Re: FCC ID H9PLA2400 Ref # 13402

Date: April 12, 2000

To: Norman Nelson, Symbol Technologies, Inc.
From: Joe Dichoso
jdichoso@fcc.gov
FCC Application Processing Branch

Re: FCC ID H9PLA2400
Applicant: Symbol Technologies Inc
Correspondence Reference Number: 13402
731 Confirmation Number: EA96849
Date of Original E-Mail: 04/11/2000

I have included the corrected page from the test report.

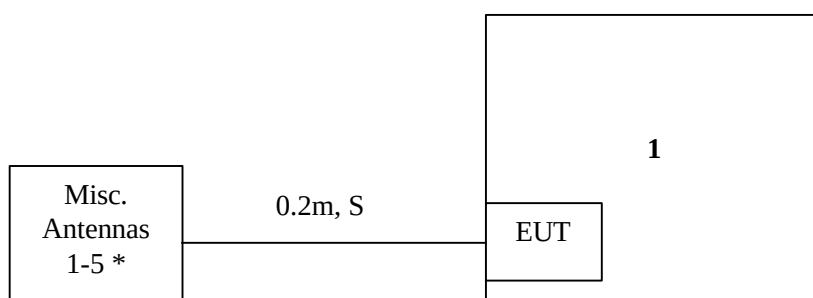
The test report indicates 5 antennas. The RF exposure info indicates 8 antennas. Only pictures of 6 antennas were submitted. Provide a correct list of antennas. For each antenna, list the type and model number and the gain. Correct the type, model number and gain in the test report, the RF exposure, antenna list. Some of the gains, model number and pictures did not agree. Please check everything.

The correct number of desired antennas in this application is $7 = 5 + 2$:

Number tested	5
Number tested withdrawn	0
Number in table withdrawn	2
Number referenced to others	2
Total in table	9
